Subject: RE: PUD / Subdivision Application at 37th and Oak

The City of Florence has received an application for a PUD / Subdivision of 25 individual lots with single family attached units at 37<sup>th</sup> and Oak St. This is scheduled for a public hearing with the Planning Commission on June 13<sup>th</sup>. Please review the application HERE and provide any comments by June 5<sup>th</sup>.

Subject: Myrtle Glen

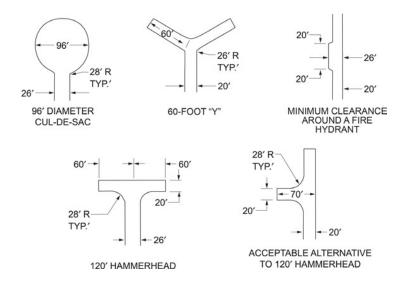
Preliminary plan looks good for street width and proposed location and shape/size of emergency vehicle turnaround. My questions about hydrants, water supply, and automatic sprinklers can wait.

D103.1 Access road width with a hydrant. Where a fire hydrant is located on a fire apparatus access road, the minimum road width shall be 26 feet (7925 mm), exclusive of shoulders (see Figure D103.1).

**D103.4 Dead ends.** Dead-end fire apparatus access roads in excess of 150 feet (45 720 mm) shall be provided with width and turnaround provisions in accordance with Table D103.4.

Do you know what the planned height of these buildings will be? Over 30 feet and I will want to look at requiring access for an aerial apparatus. The current access may be adequate.
